Certificate of Appropriateness

1933 N. 2ND ST.

Brewers Hill Historic District

PTS ID 111313 COA Build Stoop at side entry

Location where stoop will be constructed.

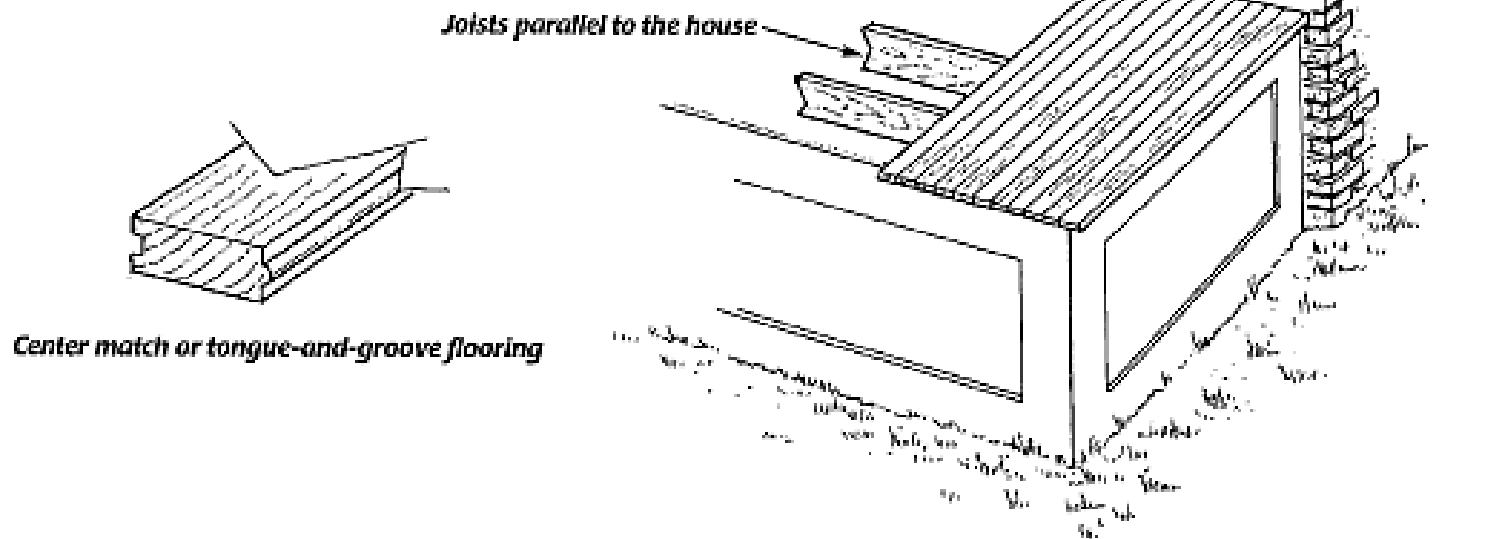
Applicant has side entrance for which there is no longer a porch or steps. He is under orders from the Department of Neighborhood Services to provide a porch (covered) or stoop (open). Applicant indicated he wanted to match the front porch but actually wants to build a stoop.

The stoop will be 45 inches wide, have handrails 41 inches tall and risers that are 7 inches tall. From the wall of the house to the last step will measure 65 inches.

All work will conform to the attached drawings. Stoop must have a deck, railings and handrails along the steps. Skirting must be completed at the base of the steps.

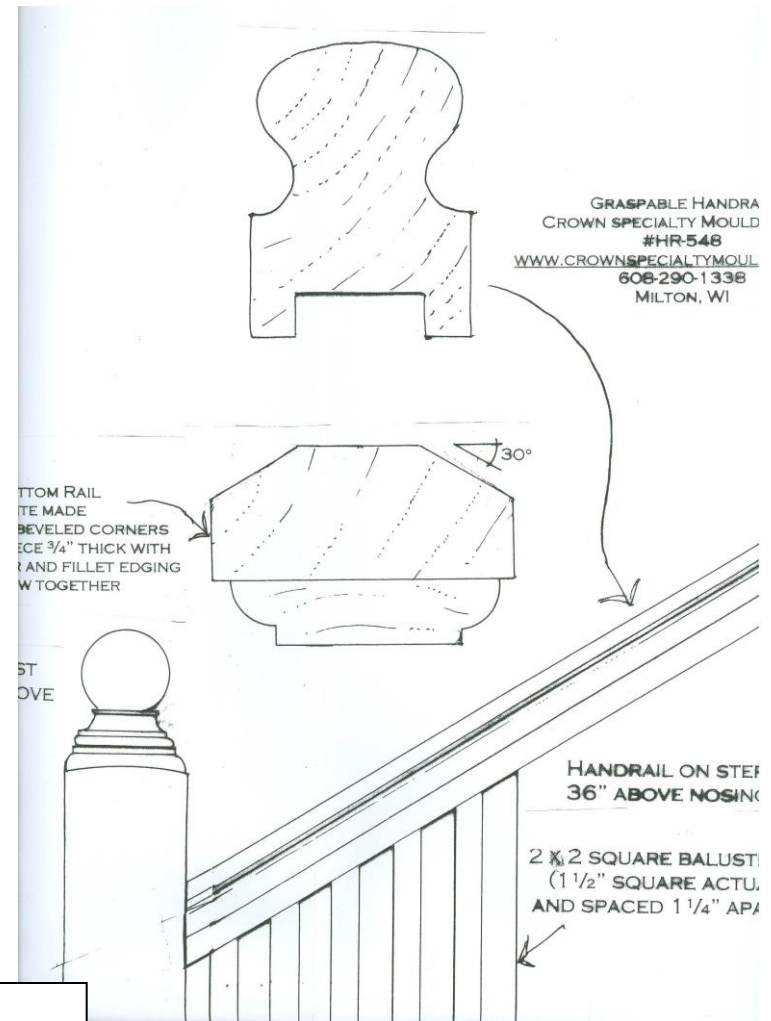
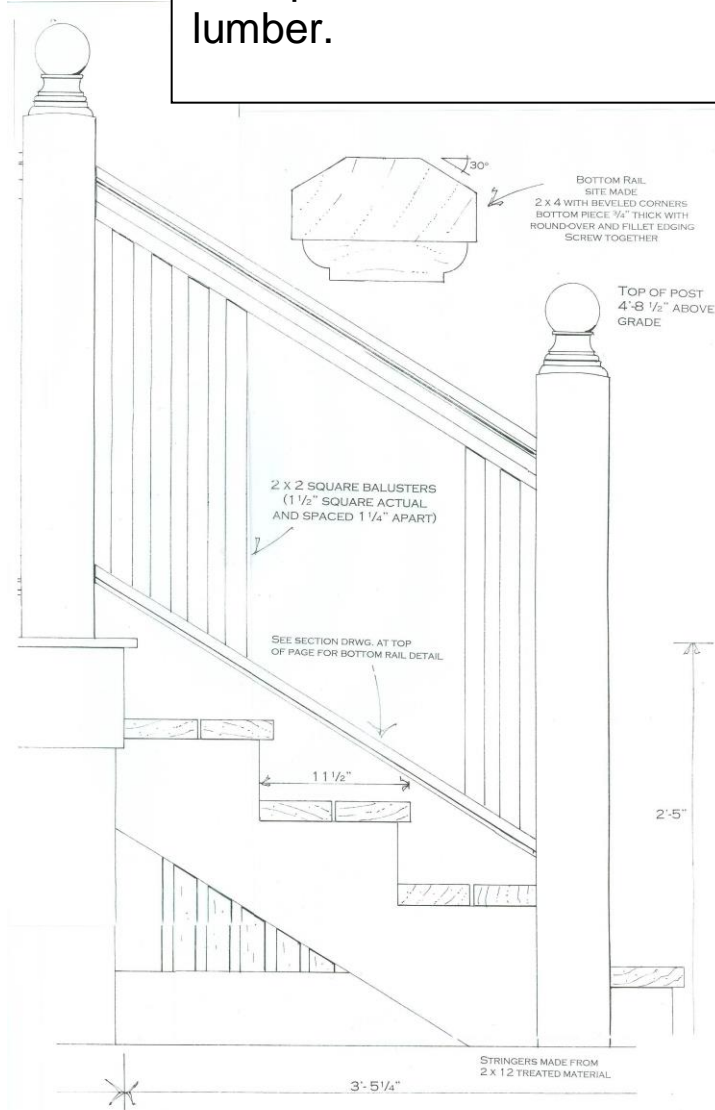
Note handrail has breadloaf shaped top for easy graspability. Bottom rail is sloped to shed water. Top and bottom rails cannot be simple planks of lumber.

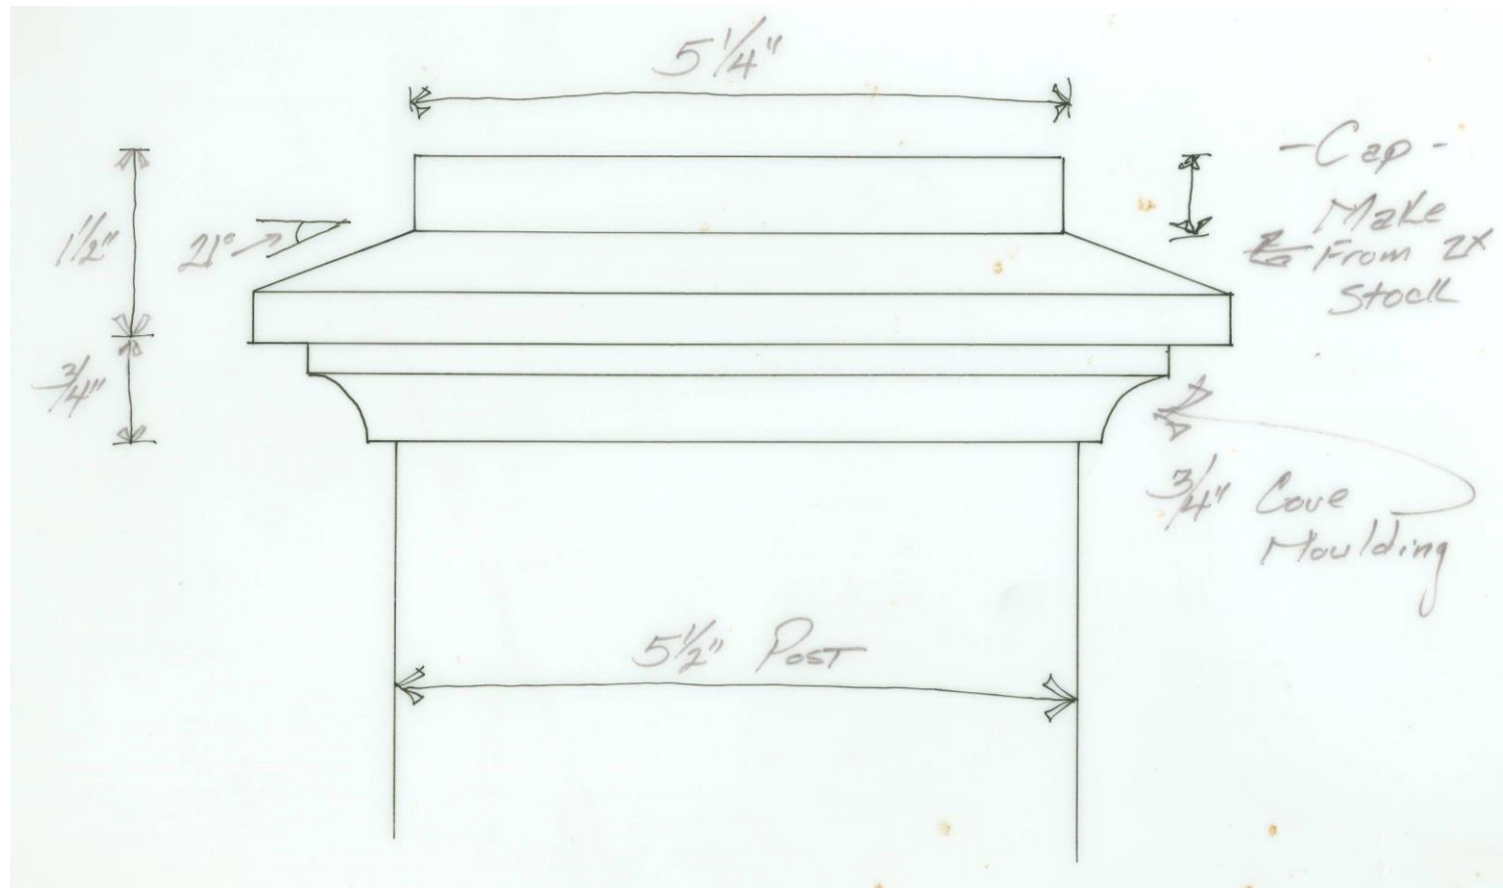
Caps on top of posts can be ball-shaped as in this example. Note simple skirting.

Tops of posts can also be square as in this example. Note use of cove molding.

Yes!

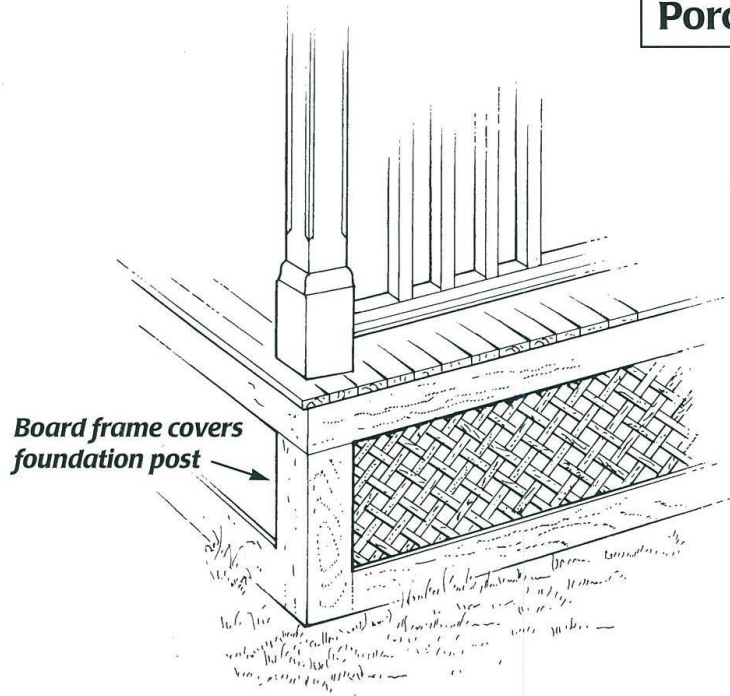
Skirting, such as this lattice panel, enclosed the area beneath the porch floor. It should always be installed with a continuous board frame around it that is wide enough to cover the rough framing lumber that supports the porch deck.

No!

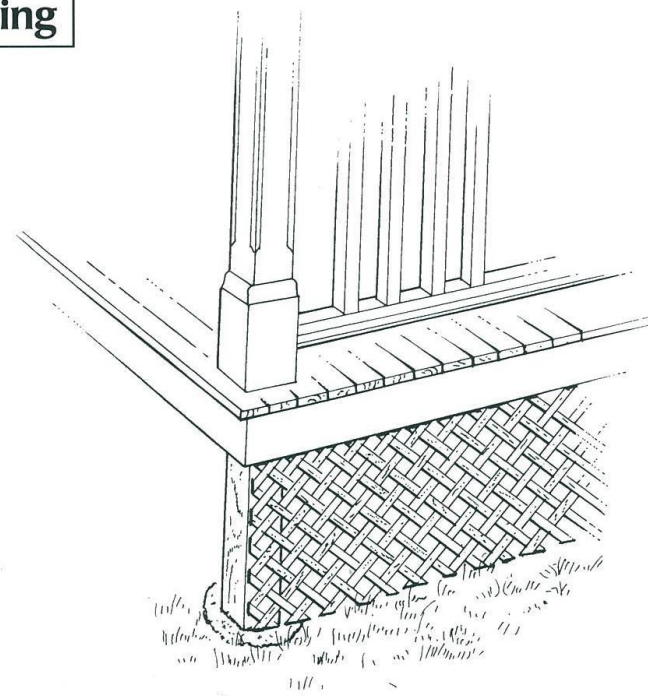
Do not install a lattice skirting without a frame around it. The rough framing lumber that supports the porch will show through and the raw edges of the lattice look unfinished.
